SERVICE BULLETIN #1196

SUBJECT IMPROVED CLUTCH GUARD ASSEMBLY, P/N 53542A

MODEL 1-43, 1-46, 1-53 DATE 9/3/62

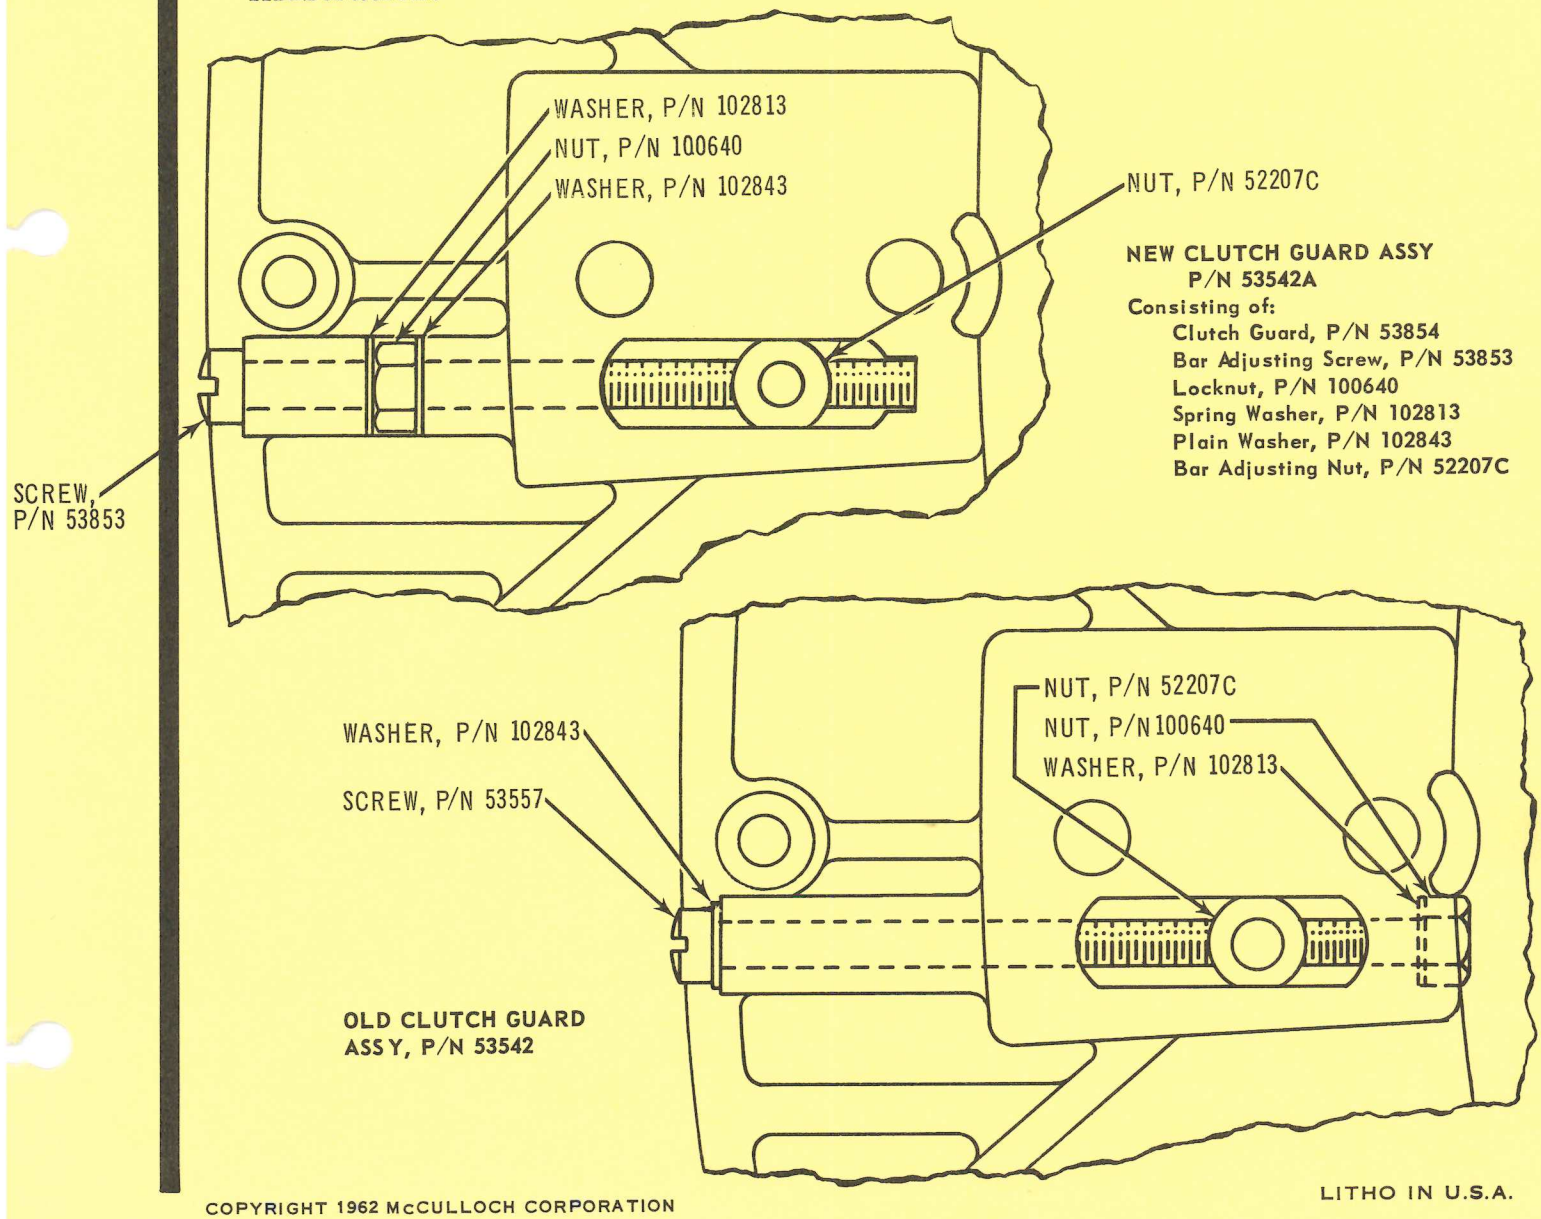
An improved Clutch Guard Assembly, P/N 53542A, designed for increased service life, is now available for Model 1-43, 1-46, and 1-53 engines. This new clutch guard assembly replaces the old clutch guard assembly, P/N 53542, and will be furnished on all replacement orders for Clutch Guard, P/N 50072C or P/N 50072D.

New Clutch Guard Assembly, P/N 53542A includes a new Clutch Guard, P/N 53854, and a new Bar Adjusting Screw, P/N 53853. Other differences in the new clutch guard assembly consist of relocation of the bar adjusting screw locknut and the washers. These differences are shown in the accompanying illustration.
